**Marbach Pump Station Improvements (Volume I) &
Mission Road Service Center Drainage (Volume II) (RFCSP)
Solicitation Number: CO-00533
Job No(s): 20-6001/21-2501**

**ADDENDUM 6
September 27, 2023**

WELLS 1, 2 AND 3
 DEMOLITION SECTIONS

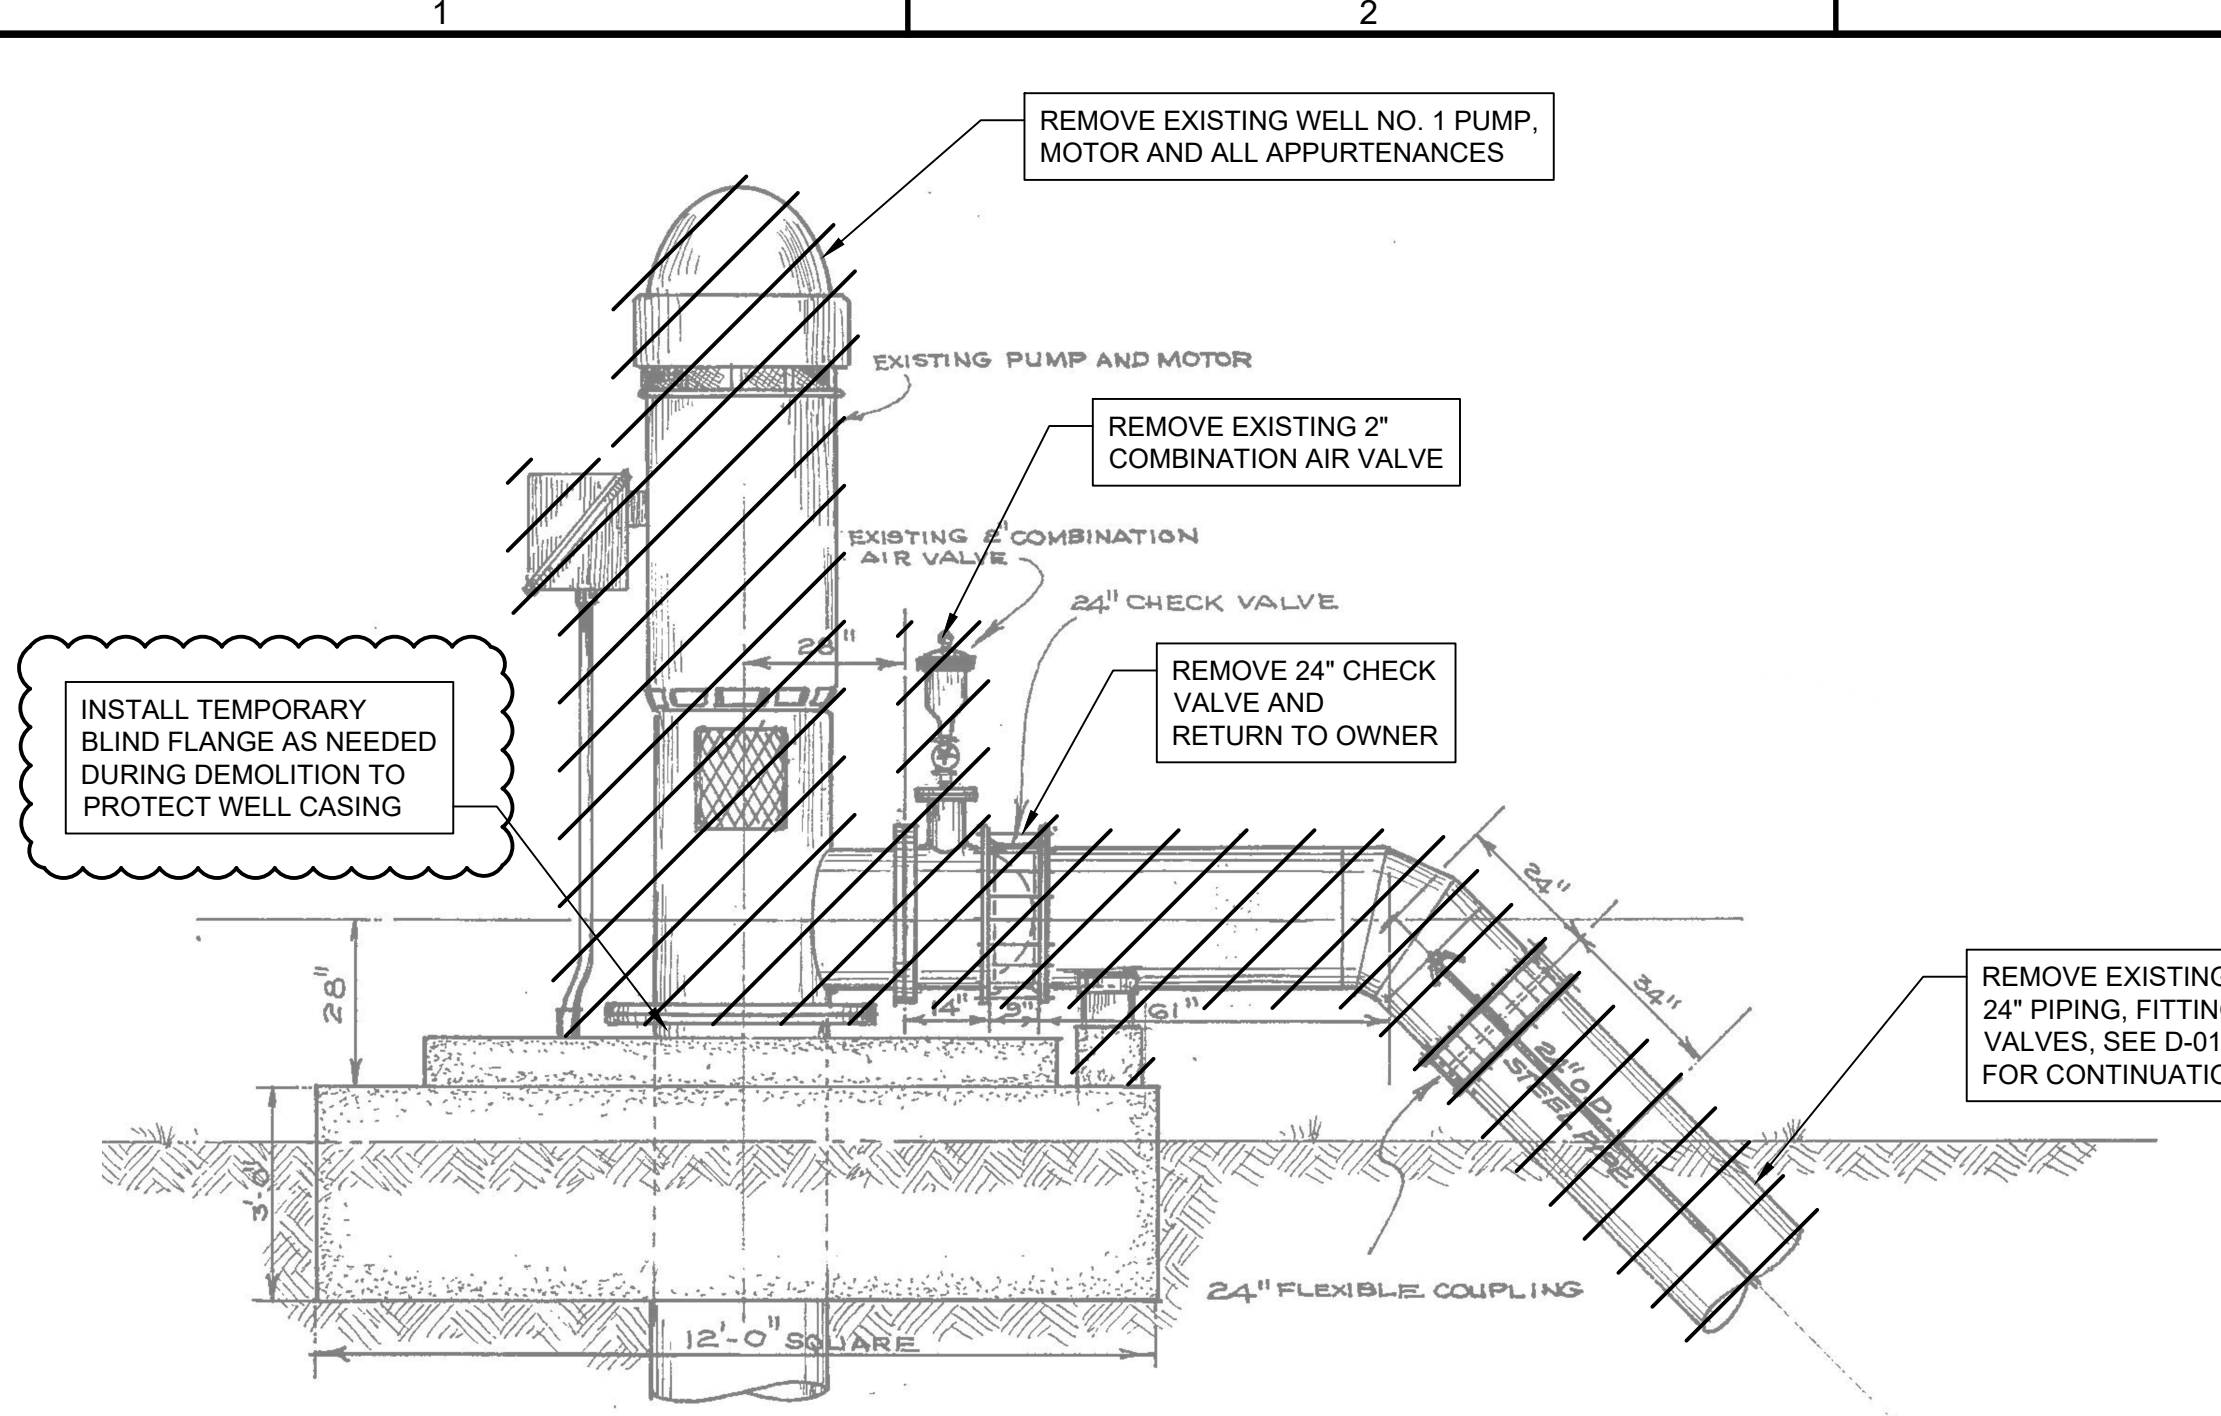
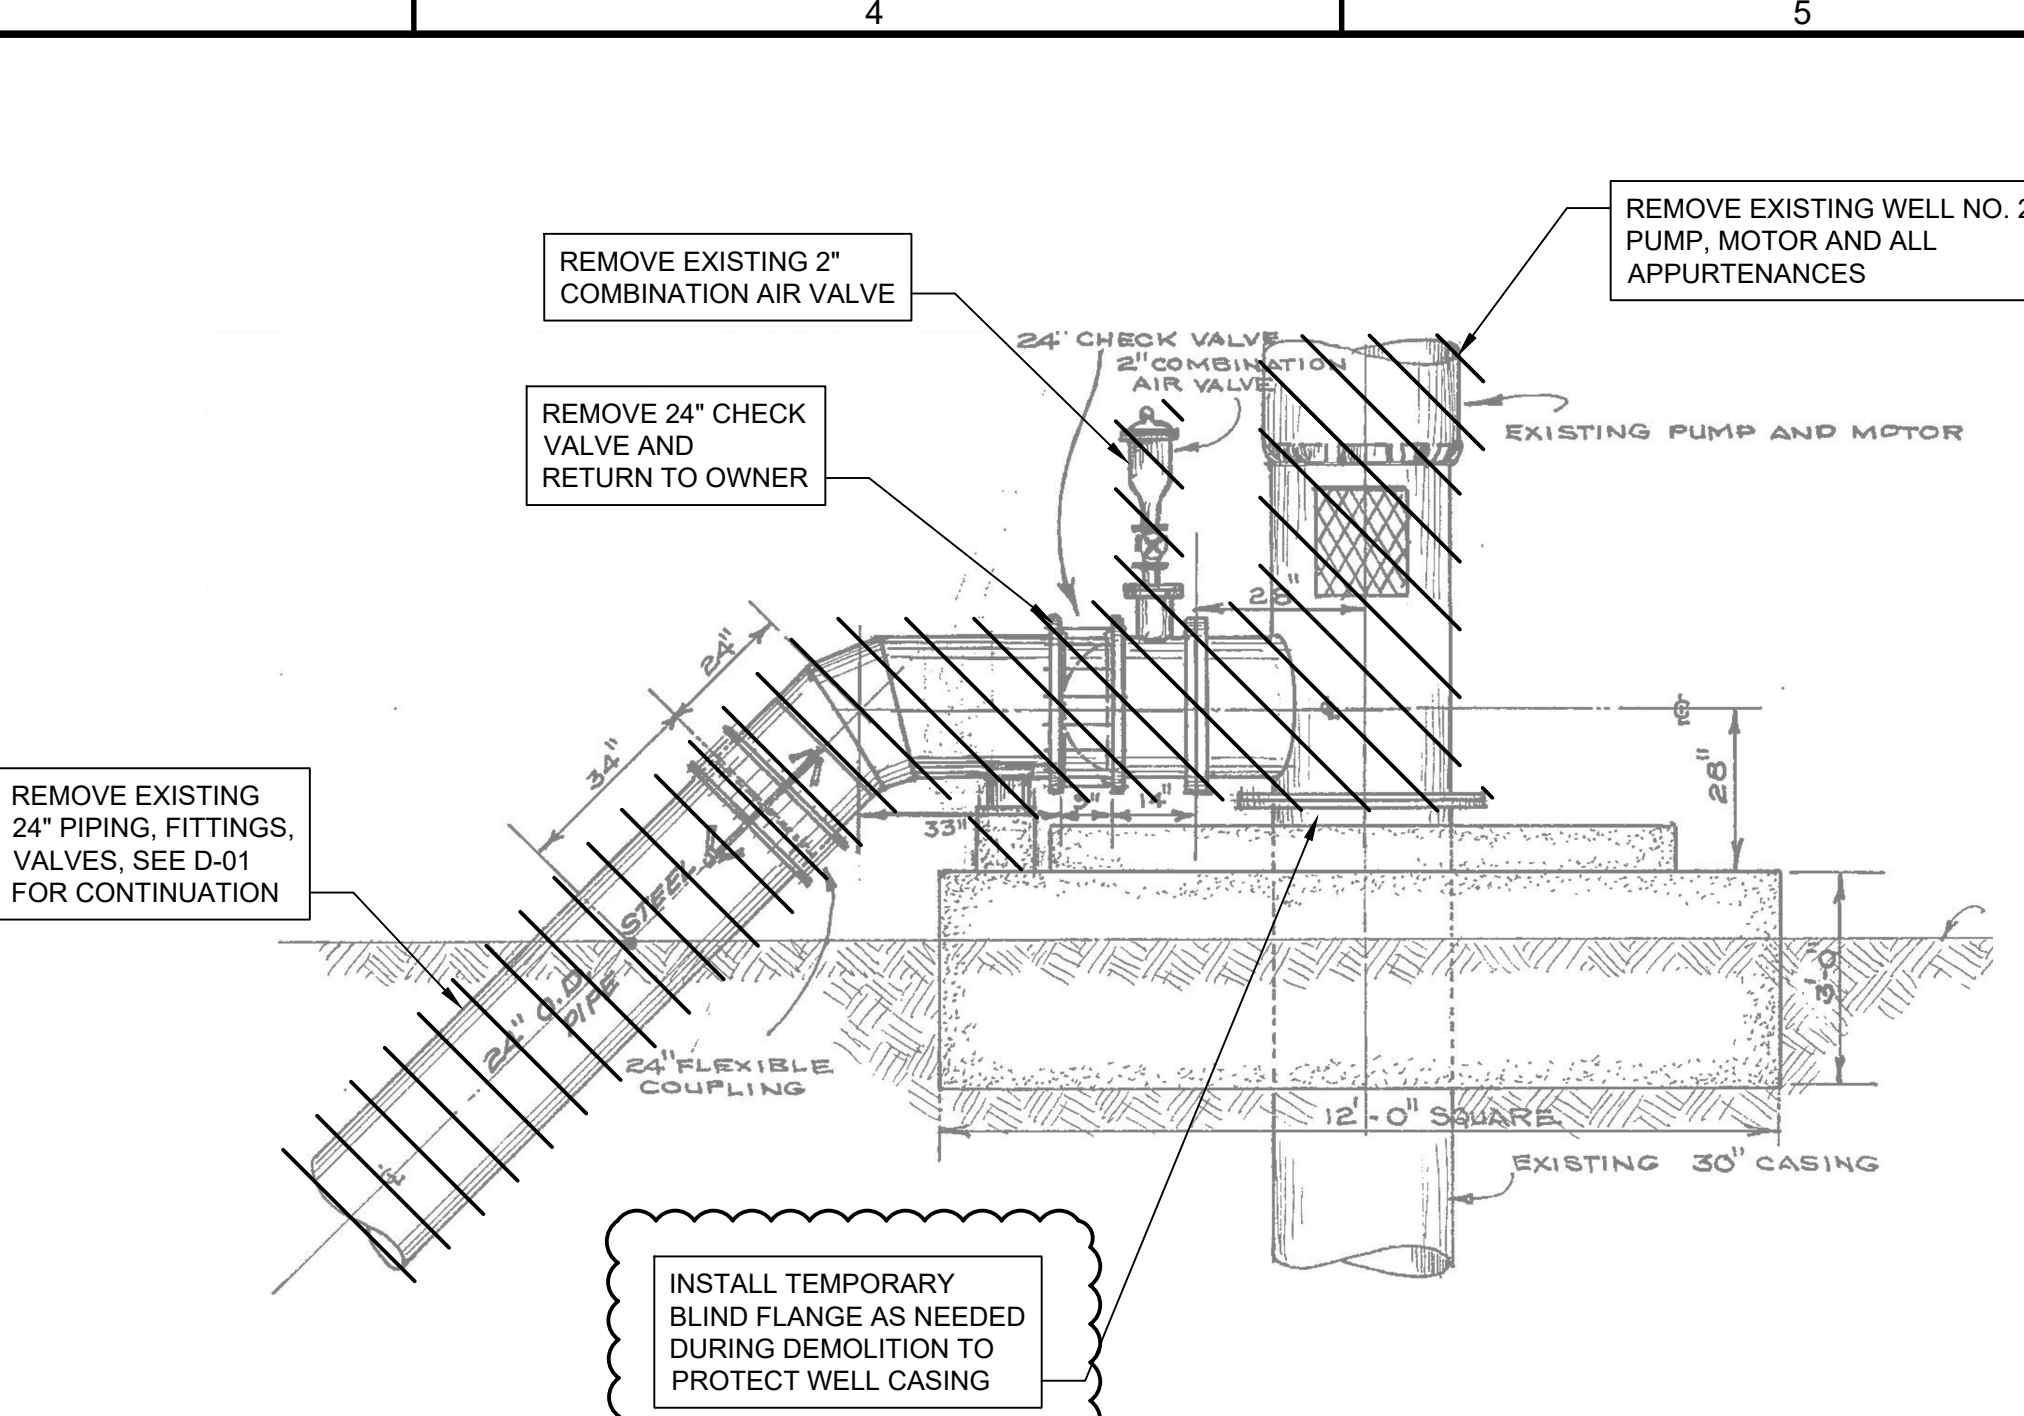
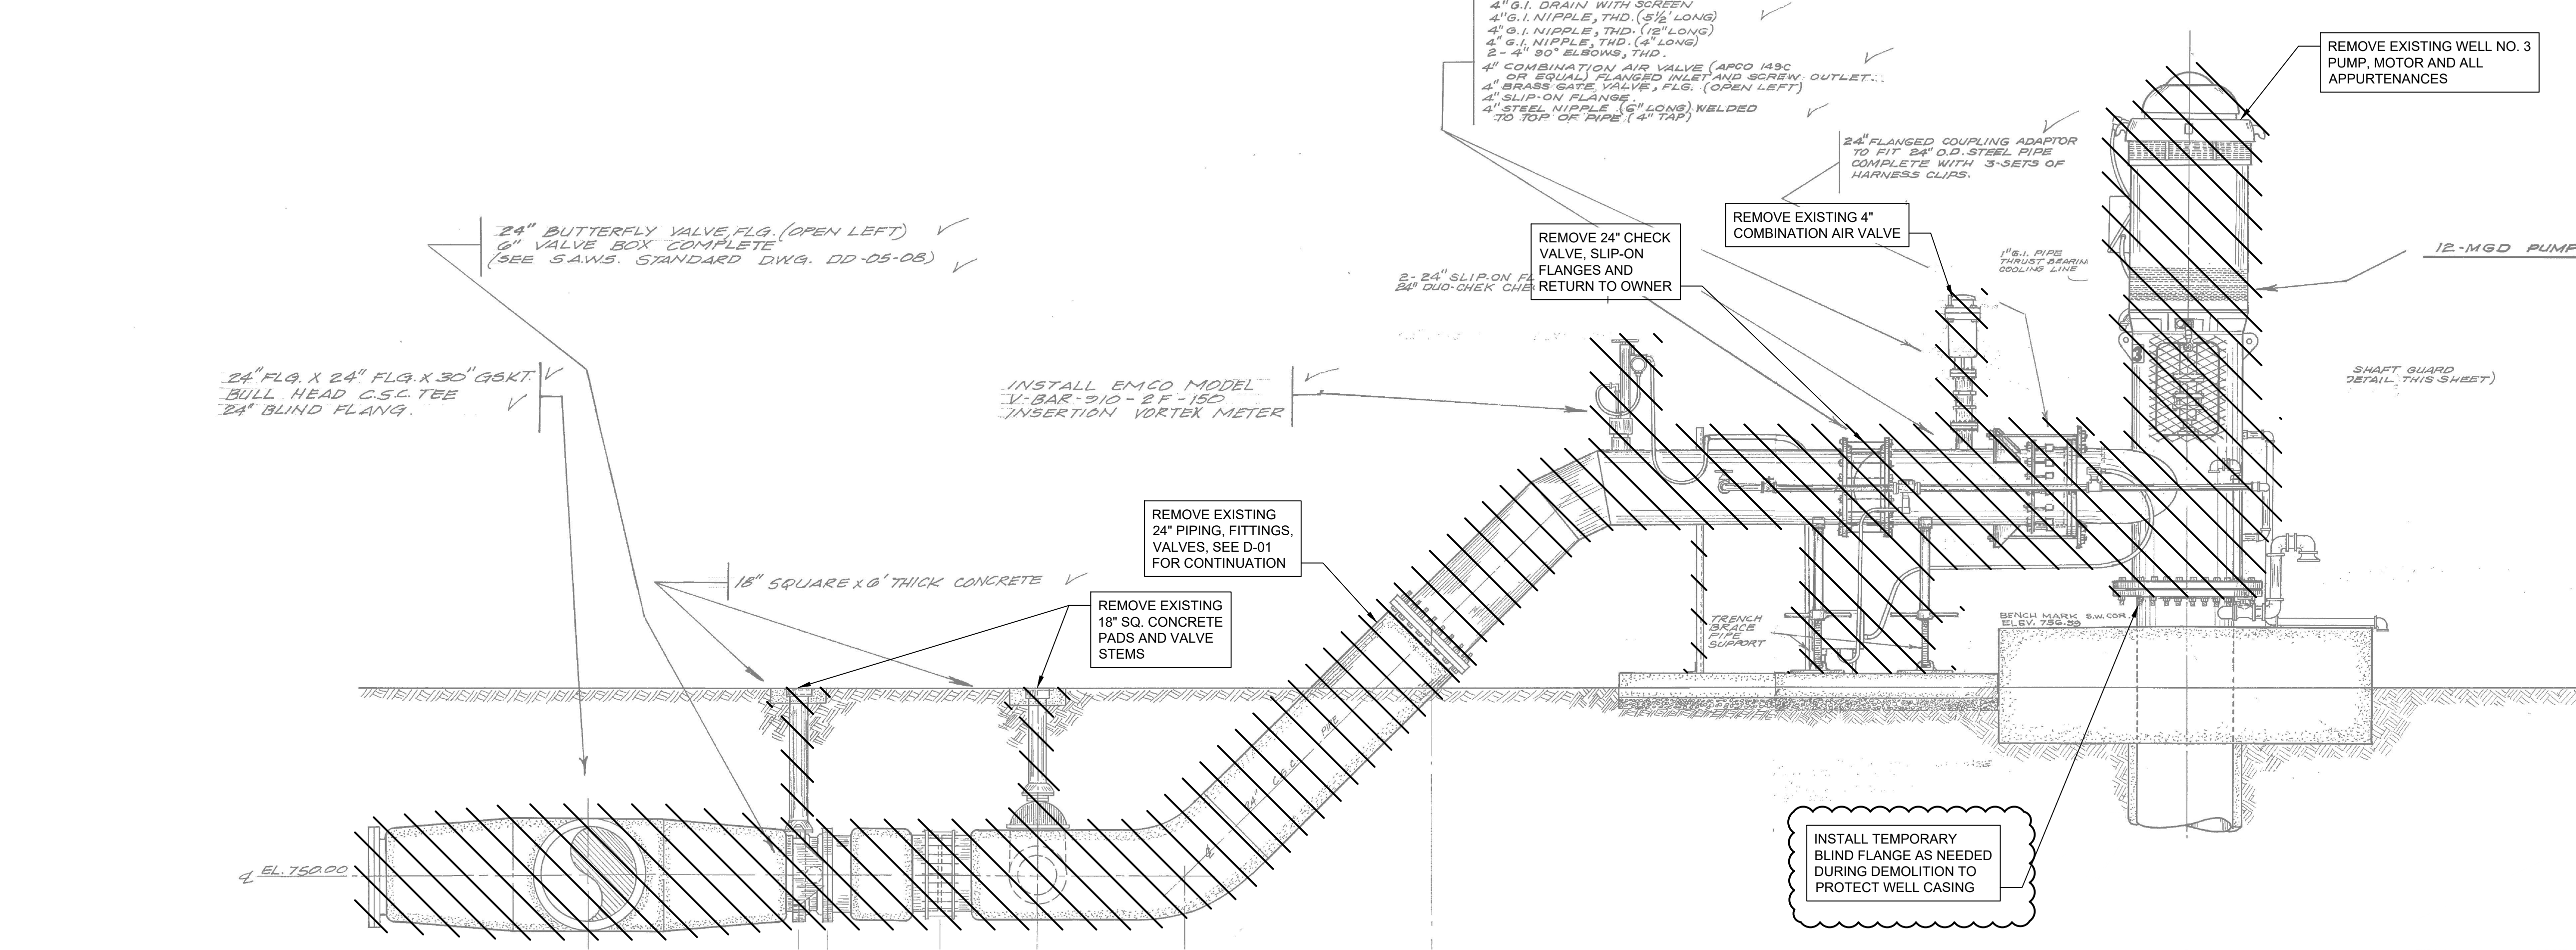
- 34. Question: D-04 – Demolition plans say surface plate top flange should not be removed. Confirm elevation of surface plates and target discharge elevation of Well Pumps 1/2/3.**

Response: Sheet M-04 Well Piping Sections shows a new soleplate to be installed and that the top flange is to be removed. Elevations to be included in Section 43 24 13.33 Vertical Line Shaft Pumps. See Item No. 19 in the CHANGES TO THE SPECIFICATIONS section of this addendum.
